## PRODUCT CHANGE NOTIFICATION

#PCN-DCT-WO28-11

Business Unit	Product Line Code	Type of Change	Action	Date of issue
DCT	176	Aesthetic	Notify Distributors and Field	02/18/2011

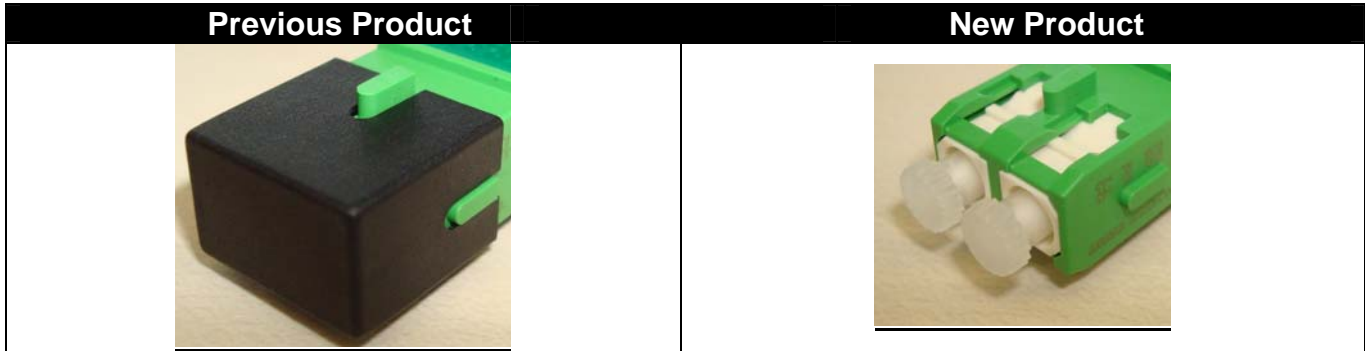
The black protective cover is changed to two clear single caps. The new caps will provide easier field testing, because now the light can shine visibly through the cap.
